# Aqua Lung America

## TECHNICAL BULLETIN

Mar 22, 2010  
No. 29

**SUBJECT: Recall Notice of the Apeks WTX Inflator.**

### PRODUCTS AFFECTED:

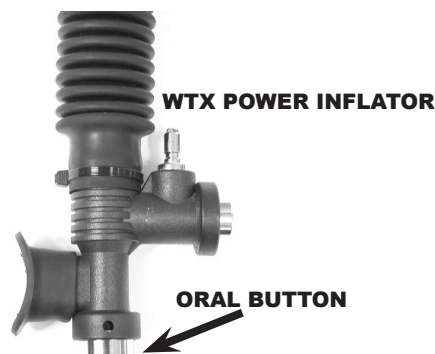
**PROBLEM:** Aqua Lung has been made aware of a case of a poorly retained oral inflate button that came off of an Apeks WTX inflator. If the button were to come off, the spring behind the button would also come off thereby removing the tension needed to keep the valve closed. If this were to occur in the water, it could lead to a leak of the BC contents out of the oral mouthpiece.

The button is supposed to be adhered with a high-strength thread locker. Our research into the matter indicates that some units may have been improperly adhered by our supplier. Because an inspection of the button is easy to do, Aqua Lung believes that it is prudent to inspect all units in the field. We believe that very few, if any, of the WTX inflators will exhibit this problem.

**CORRECTIVE ACTION:** The detailed inspection procedure as well as the corrective action has been provided to your local Aqua Lung/Apeks dealer. If you have an Apeks WTX inflator that falls into the range listed above, please return your WTX inflator to your local Aqua Lung/Apeks dealer for inspection.
